From: [Debra M. Beckwith](#)
To: [BR](#)
Subject: Advertisement (14-042a) Top strands for PS box beams
Date: Monday, March 2, 2020 8:44:46 AM
Attachments: [image001.png](#)
[image002.png](#)

The Standard Drawings have been updated as described below:

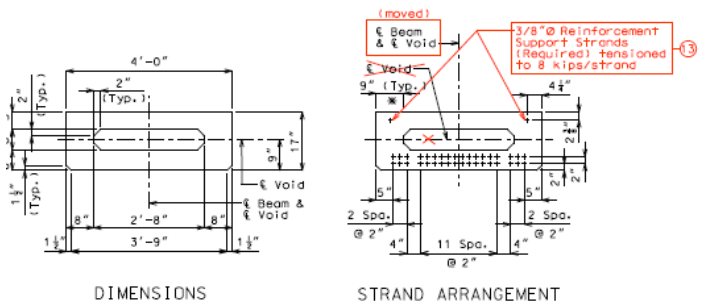
Revision Date	Items Revised	Description of Change
March 2020	EPG: NA	Added a note requiring 3/8" support strands for box beams that do not have top strands by design (see below). They are needed for support of the reinforcement cage.
	Standard Drawings: PSBXB01	
	MicroStation Cells: NA	Moved Half Elevation of Box Beam with vent pipe into the drawing and moved the one without vent pipe outside the border, since stream crossings are more common.
	Std. Specifications: NA	
	Standard Plans: NA	Created an alternate Elevation A-A for box beams with skewed ends (showing S5 & S6)

⑬ Remove this note if top strands are included in strand arrangement by design.
